**Report: TAB REPORT**  
**Function: Test, Adjust, & Balance**  
**Date: 06/27/2024**

**PROJECT**  
**06-24-24 DOMINICKS SCOTTSDALE, AZ**

Prime Steak Concepts

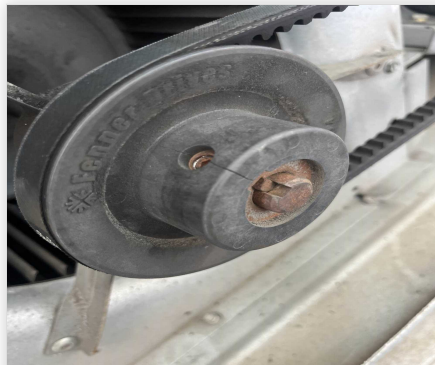
**Issue Name :** RTU-3: Pool RTU Fan Pulley Cracked  
**Description :** Plastic fan pulleys installed on Pool RTUs appear damaged. RTU-3 pulley has significant crack developing. Recommend replacement.  
**Created By :** National TAB                      **Assigned To :** National TAB - Michael McDonnell  
**Status :** Open  
**Priority :** High                                      **Asset Tag :**  
**Originated Date :** 07/26/2024 - Michael McDonnell - National TAB

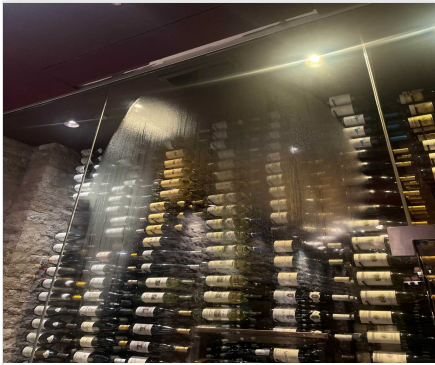
**Issue Name :** Wine Chiller: Condensate on Glass Chiller room Wall.  
**Description :** Condensate forming on wine chiller wall. Recommend unit setpoint is verified and unit is serviced. Not accessible by NTAB tech.  
**Created By :** National TAB                      **Assigned To :** National TAB - Michael McDonnell  
**Status :** Open  
**Priority :** Medium                                      **Asset Tag :**  
**Originated Date :** 07/26/2024 - Michael McDonnell - National TAB

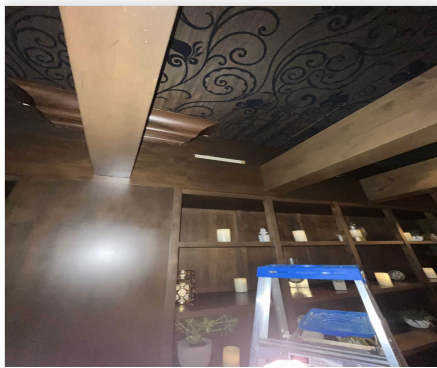
**Issue Name :** WSHP-1: Dining Diffusers Supply Wall Plenum  
**Description :** Dining room supply grilles mounted on wall in upper dining room supply the wall plenum, which then has grille sized cutouts to allow airflow. Inefficient delivery of supply airflow.  
**Created By :** National TAB                      **Assigned To :** National TAB - Michael McDonnell  
**Status :** Open  
**Priority :** Medium                                      **Asset Tag :**  
**Originated Date :** 07/26/2024 - Michael McDonnell - National TAB
